**ISSUE:** Certificate of Appropriateness for Alterations

**APPLICANT:** Old Town #1 LLC

815 King Street

Docket #8 BAR #2020-00588 Old and Historic Alexandria District January 6, 2021

Figure 1: View of 815 King Street with proposed paint color

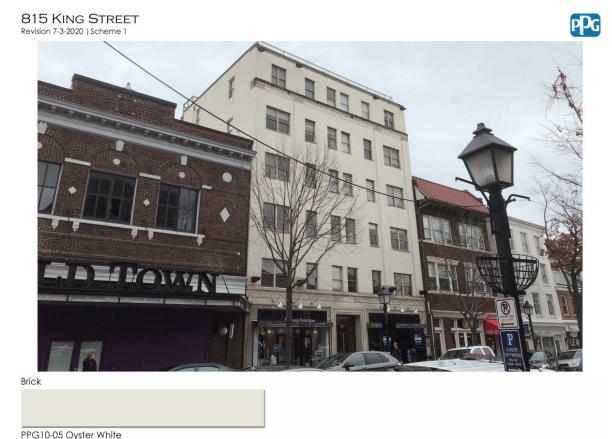
The applicant is proposing to paint the existing unpainted yellow brick at the exterior of the building an Oyster White color (Figure 1).

The BAR has always been very concerned about the painting of previously unpainted masonry and the Zoning Ordinance specifically prohibits this without BAR approval. Section 10-209(B)(4) of the Zoning Ordinance states: "The painting of a masonry building which was unpainted prior to such painting shall be considered to be the removal of an exterior feature having historic and/or architectural significance requiring a certificate of appropriateness." The *Design Guidelines* further state that "painting a previously unpainted masonry surface, no matter what color, requires review and approval of a certificate of appropriateness by the Boards. Additionally, the Boards strongly discourage the painting of a previously unpainted masonry surface."

The brick used on this building is yellow in color as opposed to the red brick used on older structures throughout the historic district. This yellow brick was popular during the 1940s and can be seen elsewhere in the district on buildings of a similar vintage. Along with the limestone details at the first-floor storefront and the 5<sup>th</sup> floor cornice, the yellow brick is a hallmark of Art Deco architecture. This building is a prominent example of this architectural style in the historic district and its preservation is critical to maintaining the diversity of design that adds to the richness and character of the district. Painting the brick on this building would remove an important defining feature of this building, damaging its architectural integrity.

For these reasons staff recommends denial of the request to paint the masonry building.
